Title: Child Checkmate is not functioning correctly

Applies To: Buses with features 47EXC, 47EXD, 47EXE built from 4/18/16 to 5/15/17

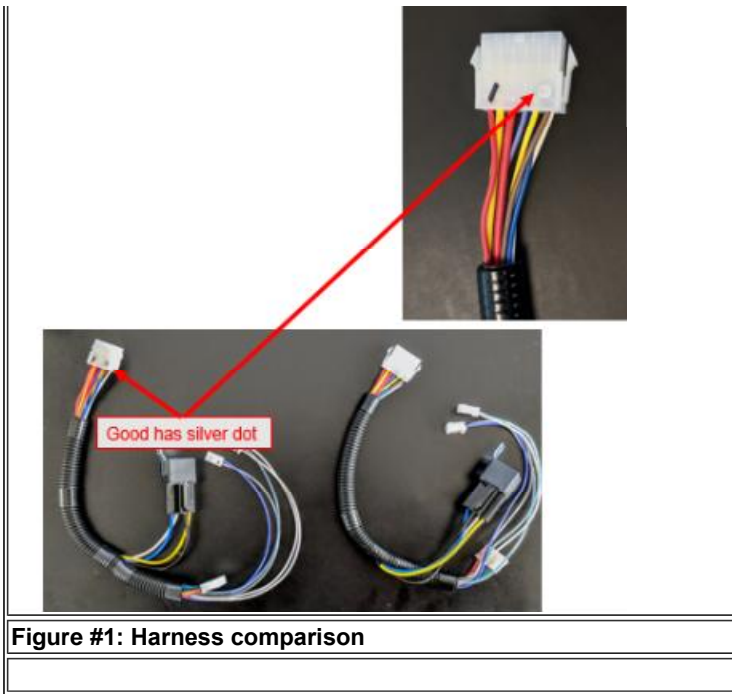
There may be a fault with the Interface Harness (A051) that was sold and used in production between April 18, 2016 and May 2017. The fault occurs with the horn and possibly the interior lights of the vehicle. The harness may prevent the horn from sounding and the dome lights to illuminate. To remain consistent, Child Check-Mate System, Inc. is advising all A051 Harnesses sold within this time to be replaced

Replacement harness will be supplied by Child-Checkmate, contact info below. Ask for replacement for Interface Harness (A051). See Figure 1 below for harness comparison.

1. Open electrical panel access door below drivers window.
2. Unplug old harness and discard

1. Install new harness
